Location/Beam	Decay viewed from bearing side	Cross plan view		Photographs	Confirmed agreed repairs with Structural engineer comment in bold
G/VB2 Bearing end to beam opposite VB4 section		300mm from the bearing end opposite VB4 pocket of decay 25mm deep 300x170mm in section		Recommendations De-frass the decay back to sound timber and splice a new section wedge shaped glue with Sikadur 31 EF 2 Part Epoxy Structural adhesive Buro Happold Comment Agreed with repair as per standard notes as per BH email dated 2-12-2024	
G/VB/6 Bearing end opposite VB4		300mm from the bearing end opposite VB4 pocket of decay 75mm deep 500mmx125mm in section		Recommendations Flitch beam plate repair as per drawings and calculation provided by WMI Consulting Buro Happold Comment Agreed with repair as per standard notes as per BH email dated 2-12-2024	
G/VB/8 Bearing end opposite VB10		Small pocket of rot to top edge 50x150mm in section to maximum depth of 20mm		Recommendations Defrass the beam end back to sound timber and treat with Probor 20 fungicide gel Buro Happold Comment Agreed with repair as per standard notes as per BH email dated 2-12-2024

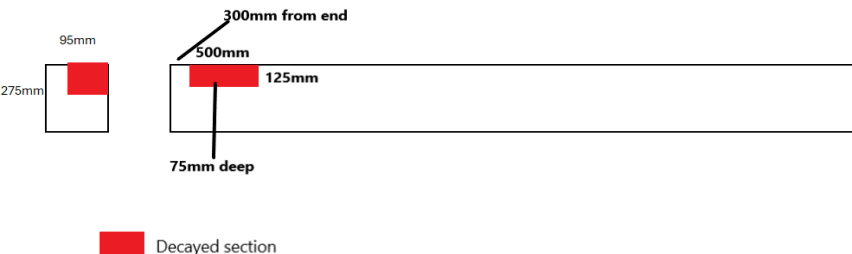
G/VB/9 Bearing end opposite VB7		Rot to top edge 50x400mm wide to maximum depth of 20mm		Recommendations Defrass the beam end back to sound timber and treat with Probor 20 fungicide gel Buro Happold Comment Agreed with repair as per standard notes as per BH email dated 2-12-2024

Sarking board

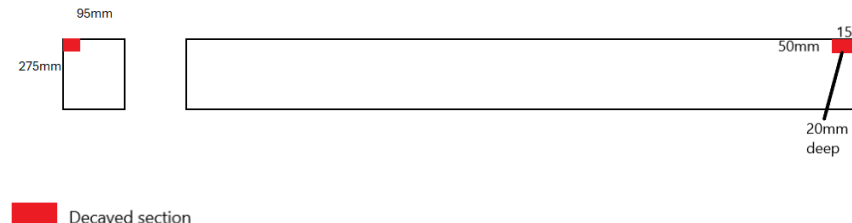
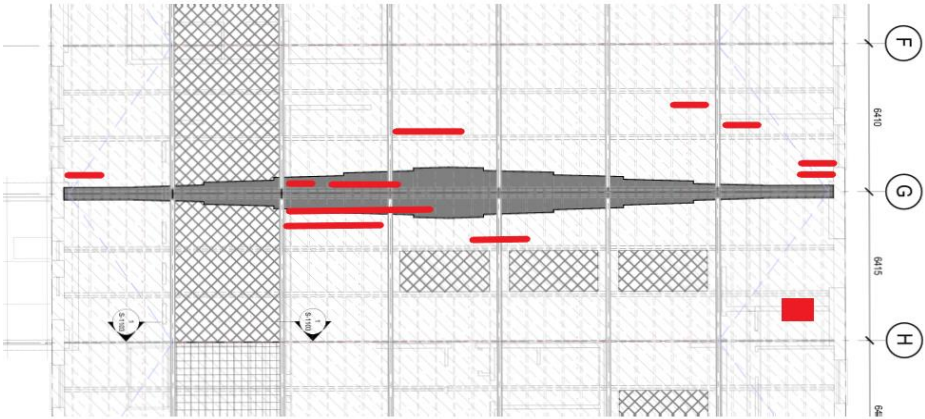
Renew damaged and decayed sarking boards

Renew with Redwood 19x225mm boards

Buro Happold Comment
Replace all decayed sarking boards
like for like as per BH email
dated 2-12-2024
